Expert Opinion on Landfill Gas, Hume Planning Scheme Amendment C207: Sunbury South Precinct Structure Plan

Hi Quality Quarry Products Landfill, 600 Sunbury Road, Bulla

Prepared for:
Victorian Planning Authority
35 Collins Street
Melbourne VIC 3000

14 August 2017

Figure 2: Conceptual Cross Section

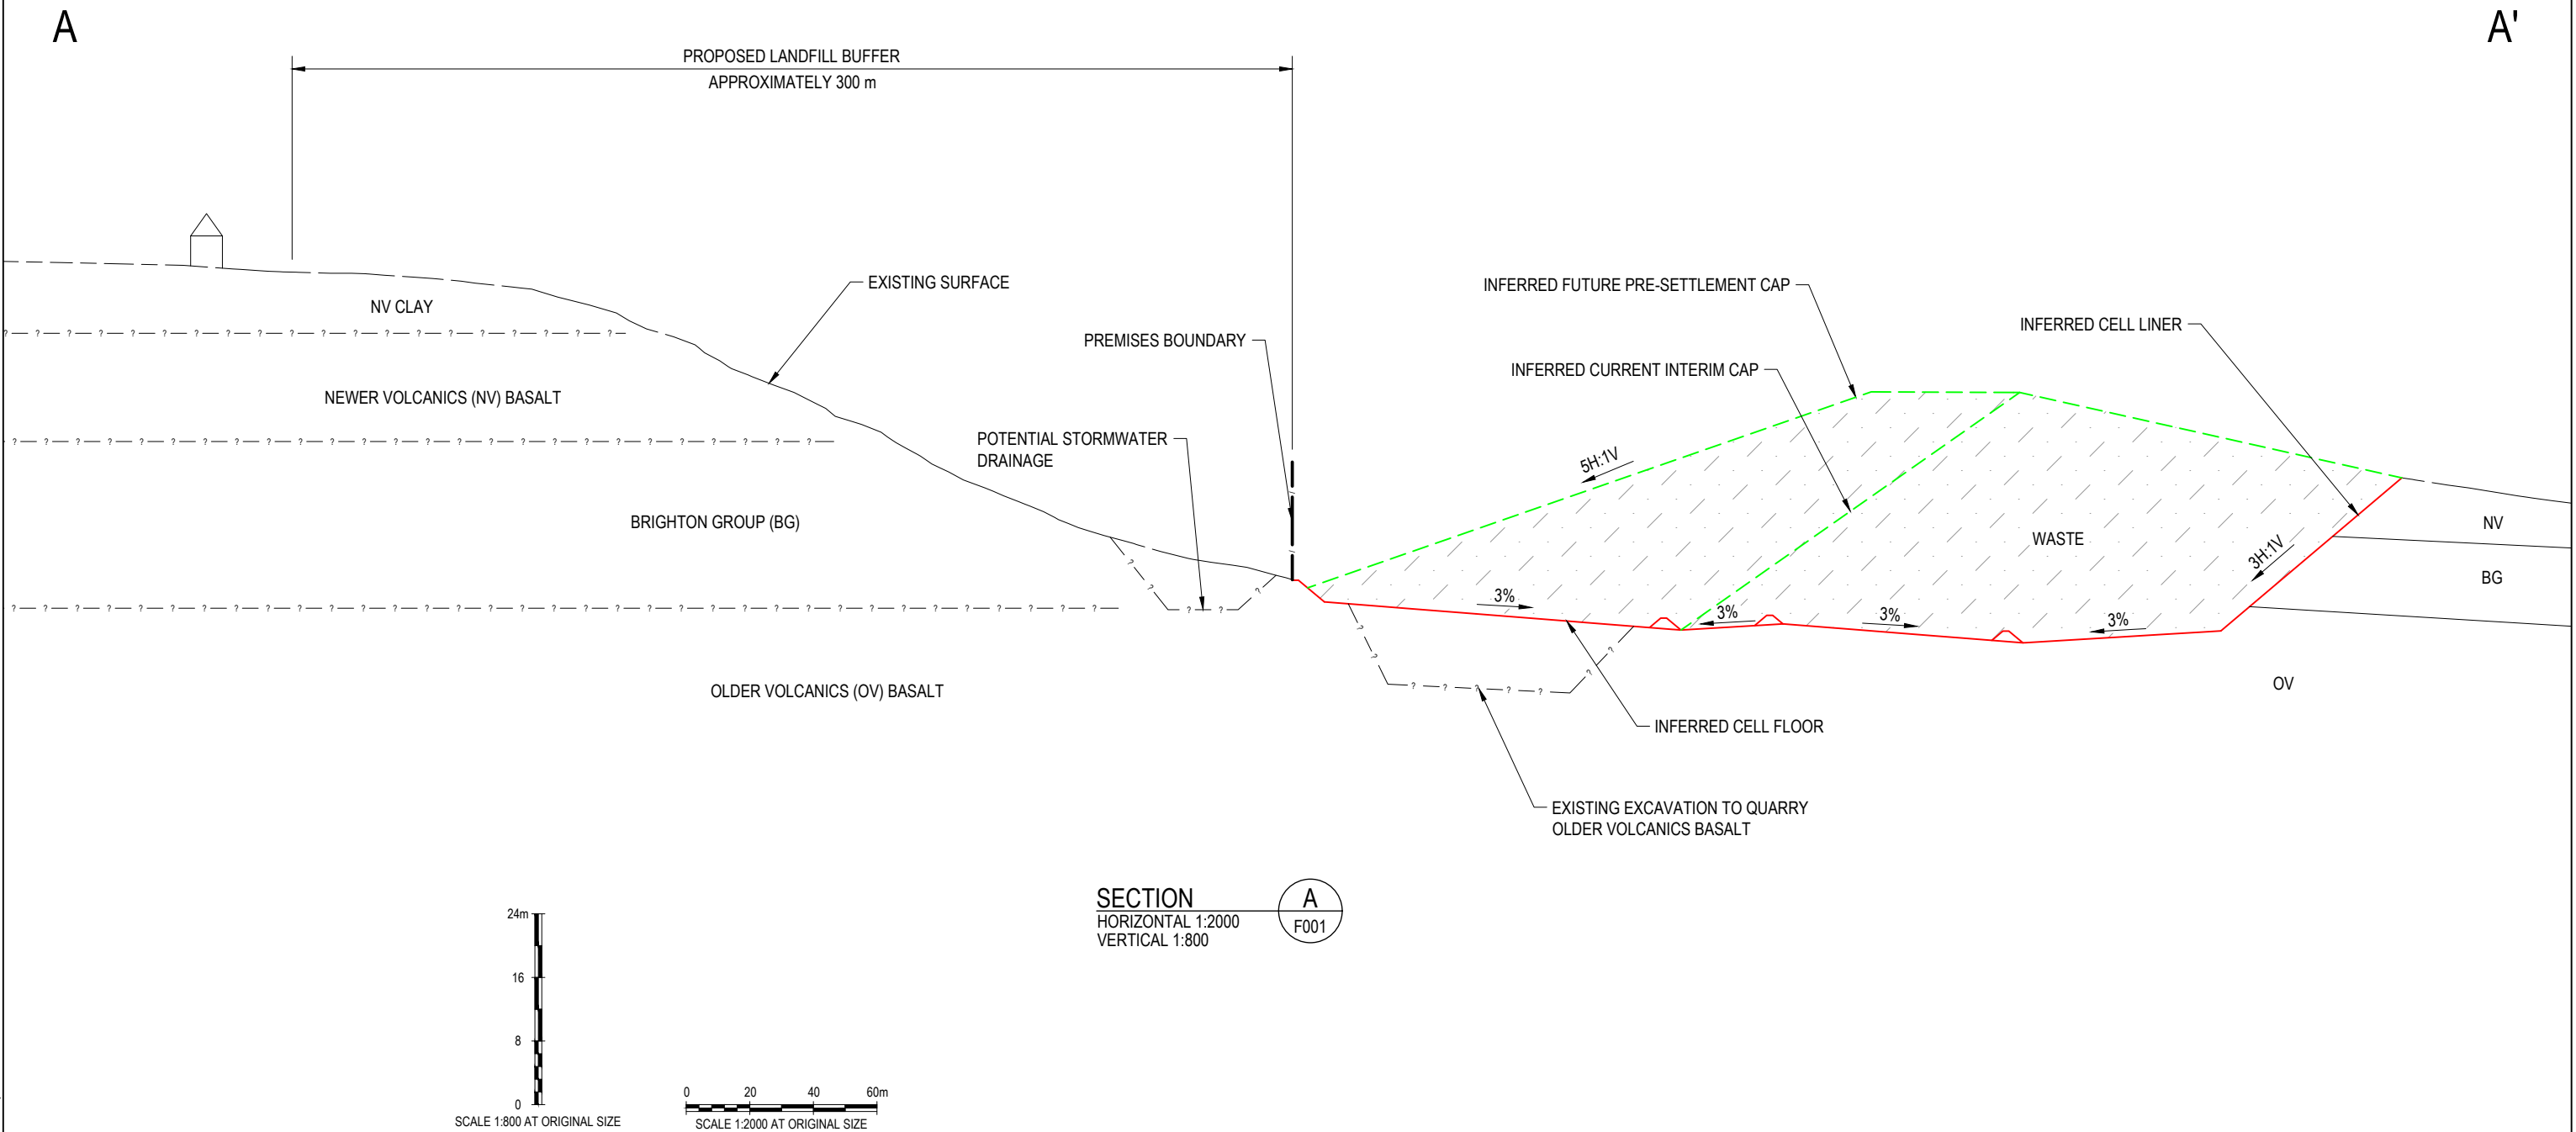
The landfill cell construction details and the information provided by Mr Ingrams were used to develop the conceptual cross section (A – A') included in **Figure 2**.

A conceptual cross section showing the potential lithological sequence around the northern cell development (Section A - A' shown on **Figure 1**) is presented in **Figure 2**.

An example of a landfill gas interception system that could be installed at the HQQP Landfill, with the potential to significantly reduce landfill buffers, would be to backfill the western side of the excavation beneath the future landfill cell on the western boundary with a permeable material (e.g. basalt screenings). A high permeability trench would allow landfill gas moving into the Older Volcanics beneath the landfill to vent to atmosphere before it crossed the site boundary (refer to **Figure 2**).

Typical potential pathways for landfill gas migration include more gas permeable layers within the natural formations, loosely compacted fill and porous backfill around underground services. Elements of potential pathways from the source, waste in cells, to sensitive receptors west of the HQQP Landfill are illustrated in **Figure 2**.

Figure Title: **RECOMMENDED BUFFER**

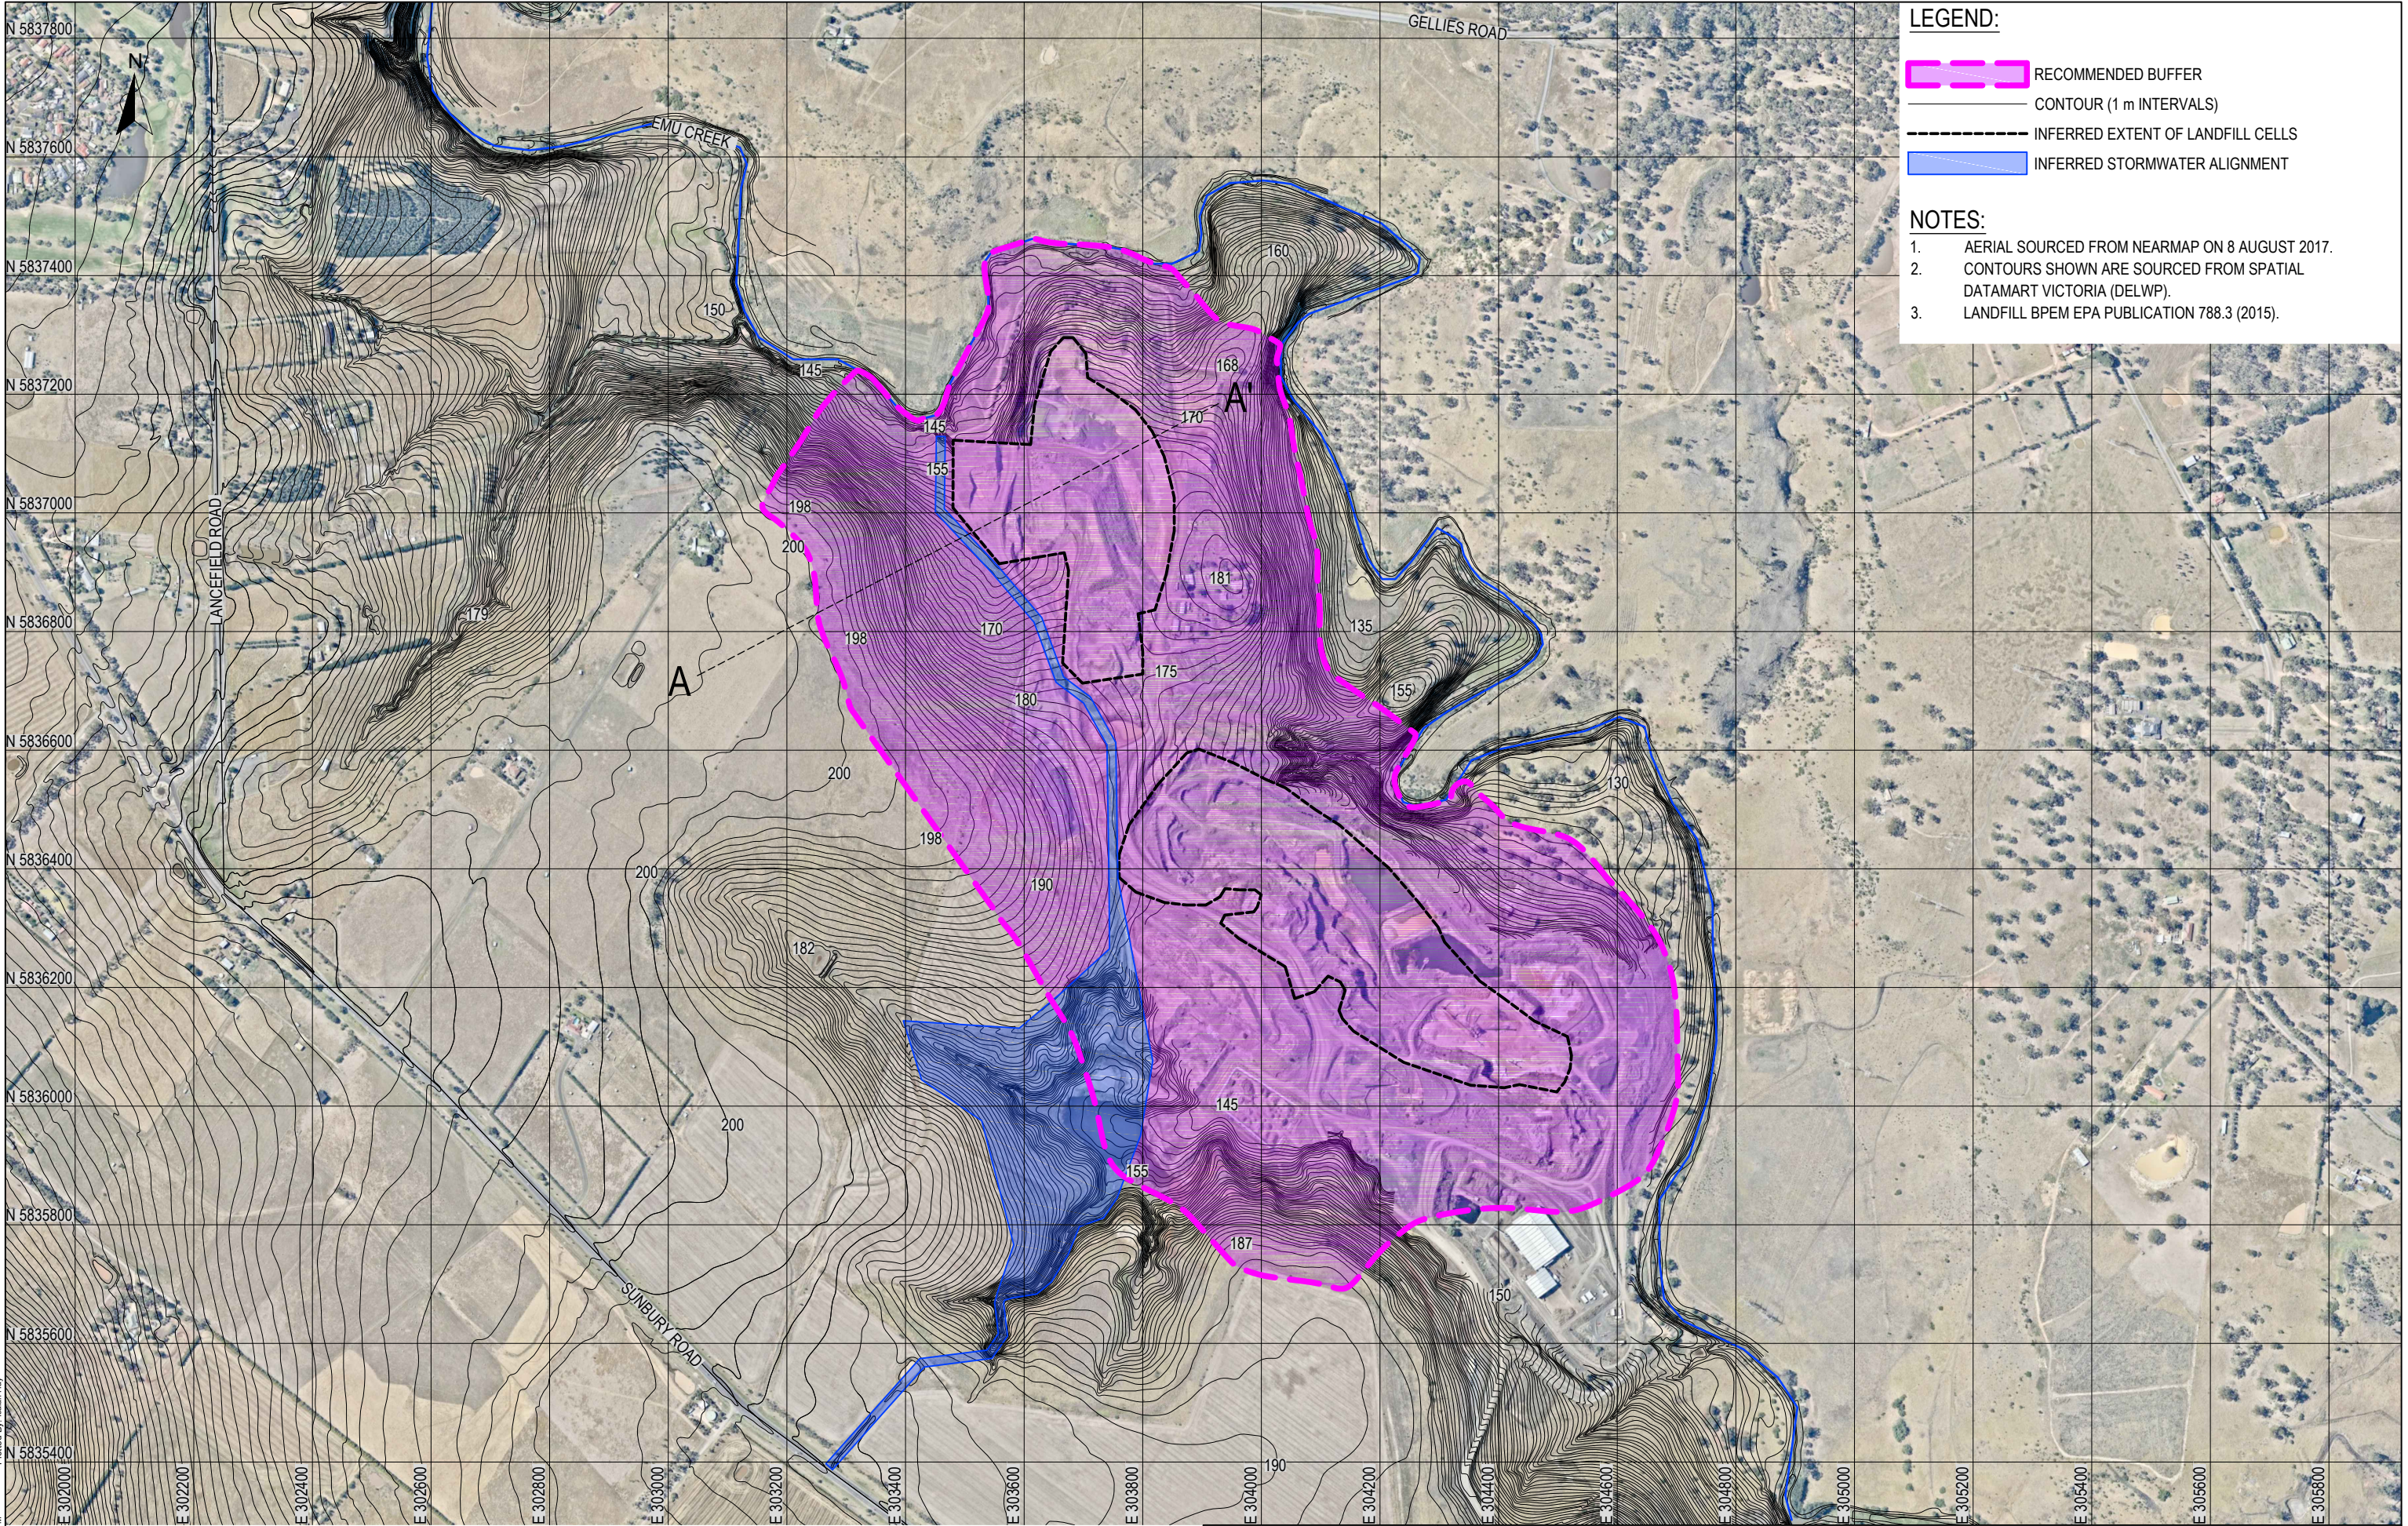
My recommendation on the extent of landfill buffers in relation to subsurface migration of landfill gas is presented in **Figure 3**.

The extent of the landfill buffer is based on the 200 m buffer distances required for Type 3 landfills with the following modifications:

I am recommending that the landfill buffer in these directions extend beyond the required 200 m buffer to approximately 50 m beyond the break in slope at the margins of the plateaus, where sensitive uses will be located under Amendment C207. I have assumed the 198 m AHD contour line and 187 m AHD contour line represent the margins of the western and southwestern plateaus respectively (refer to **Figure 3**). The maximum extent of the landfill buffers in this direction would be approximately 315 m from landfill cells.
